Environmental Review Team Report

Hebert Subdivision

Woodstock, Connecticut

July 1979

Preliminary Subdivision Plan

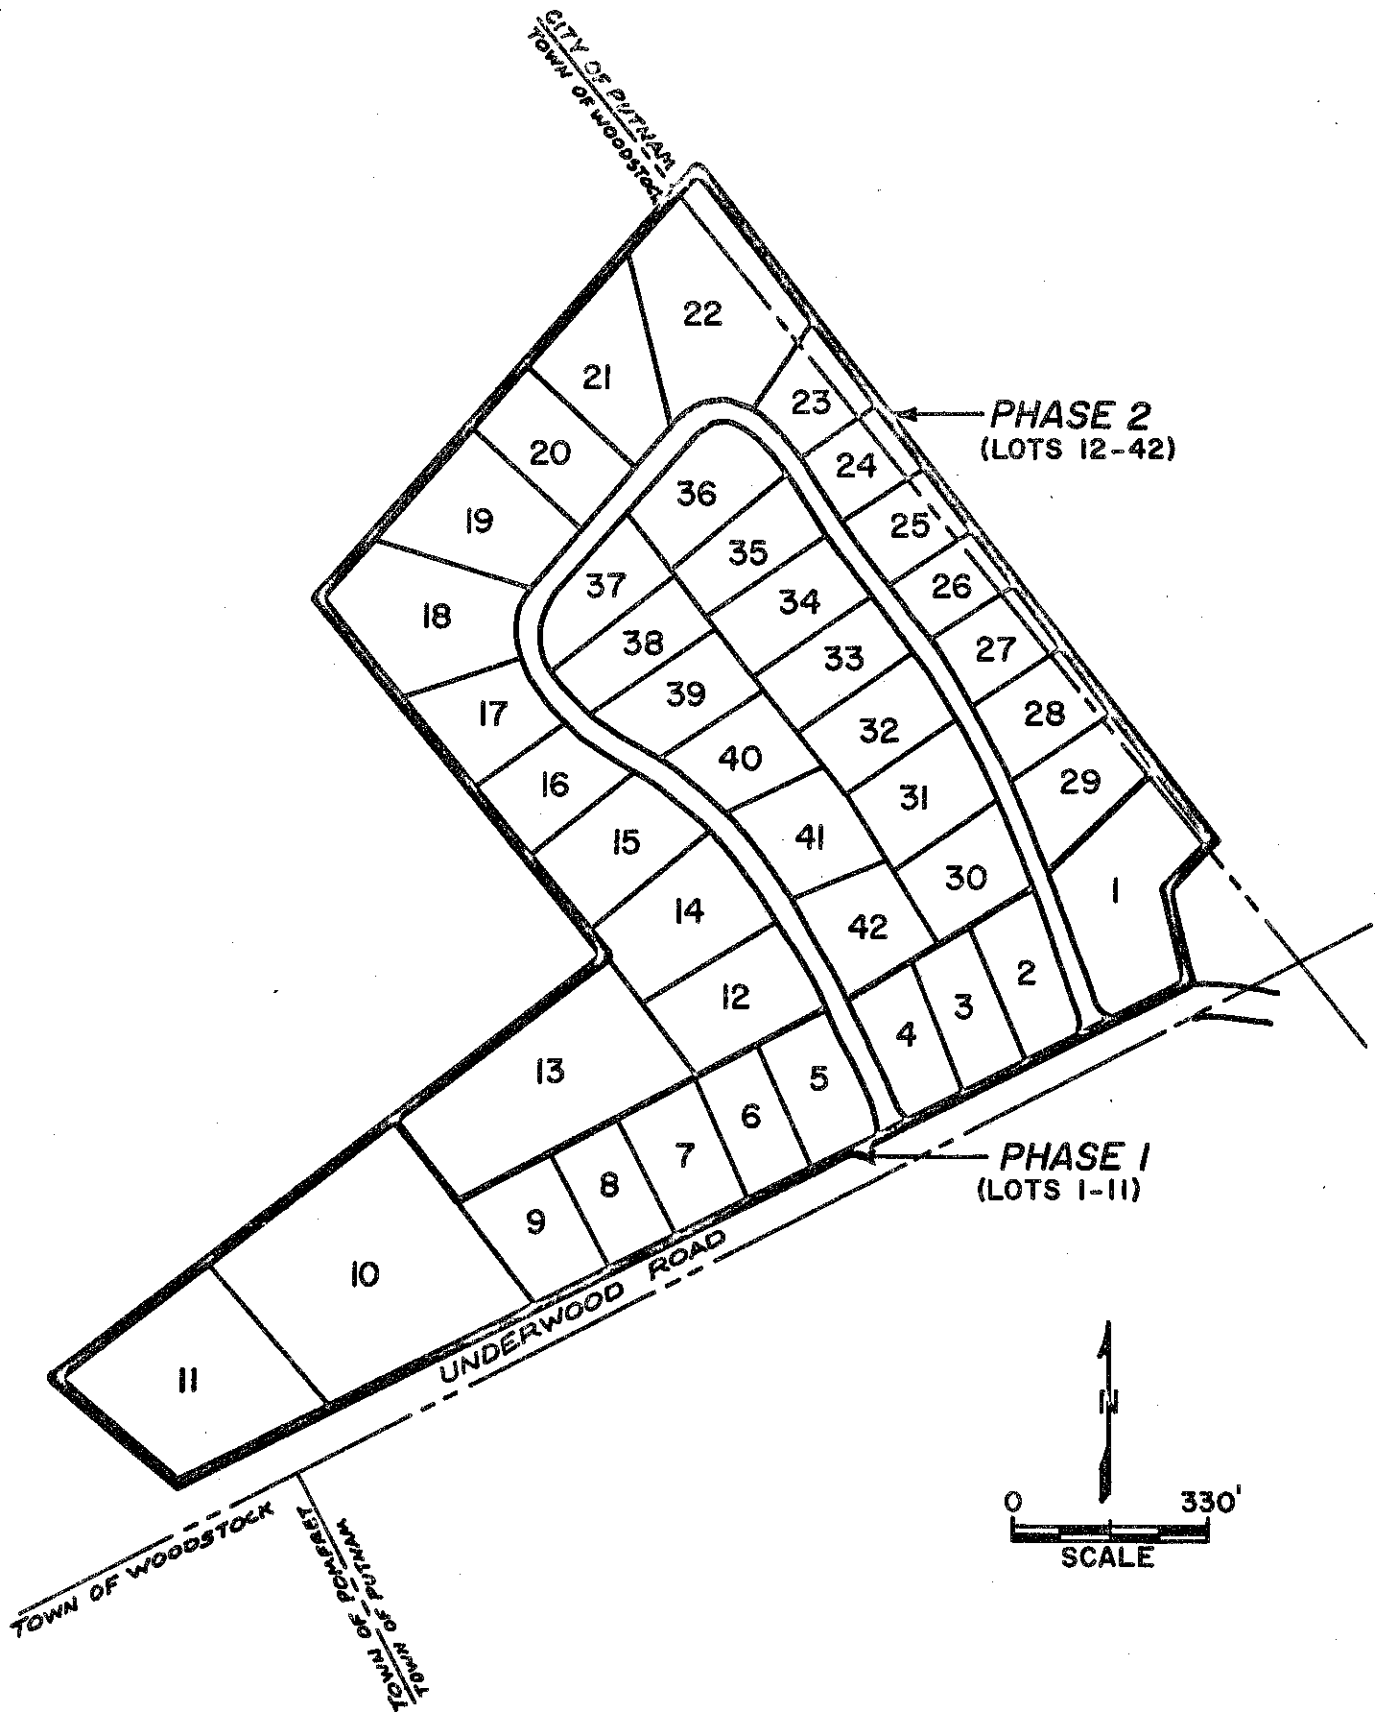
Field investigation of lots #10 and #11 reveal feasible locations for homes, onsite septic leach systems and driveways - all near, but apparently out of the wetland. Engineered systems would be needed. The existing shallow pond at the eastern side of lot #10 might be considered useful for fire protection. This would require deepening, and possible installation of a dry fire hydrant. A culvert should be installed beneath the access drive to allow for pond overflow to the stream. The invert elevation of this culvert should be low enough to prevent driveway flooding. The elevation of the stream level is low enough presently not to flood the higher building elevation on lot #11. However, north of lot #11 the stream must continue its course and not be constricted or it may conceivably flood back on lot #11 and even #10. Building in a wetland is not condoned. The Commissions should have the wetland boundary flagged in the field by soil scientists for reference.

In phase II although the layout is very preliminary, general comments can be made. Onsite investigation of the soils reveals less serious limitations than anticipated. The slope is obviously steep to the north. The location of the road could be moved southward and upslope to avoid placing driveways, homes, and septic systems on grades of 15-25 percent. This would involve proposed lots #19-22. Bedrock in this area was seen as possibly presenting a problem for basement and septic system installations. Enlarging lot sizes and reducing the number of lots will be necessary to "fit" building sites to the topography.

It would be possible to develop a storm water retention basin in the vicinity of proposed lot #18 and lots #21, 22. Installation is encouraged, at least on a temporary basis during intensive development, if storm drainage is outletted in these areas. Storm drainage facilities including retention basins for runoff and sediment should be installed along with roads before uphill land is disturbed for building construction. The peak storm drainage discharge from the development should ideally be limited to the peak ten (10) year - twenty four hour runoff, prior to development, by the retention basins (see "Erosion and Sediment Control Regulations" in Appendix B.

A sizeable portion of phase II rests on Sutton soil. Although lacking a hardpan, seasonal wetness is a problem. Potential drainage problems with lots # 13-18 should be anticipated. Footing drains, careful surface grading - (sloping away from bulkheads, etc.) will be necessary. Also, road drainage systems should be carefully engineered.

The area adjoining the northern boundary of the property contains some very steep slopes. These slopes should definitely be avoided for any type of construction, or for the installation of septic systems. This involves the back sections

of what appears to be the proposed lots #19, 20, 21, 22, and possibly several others. Sufficient level area might be provided by combining lots or extending lot lines into the center of the entire property. This would necessitate moving the position of the road and also combining lots in the center of the road loop.
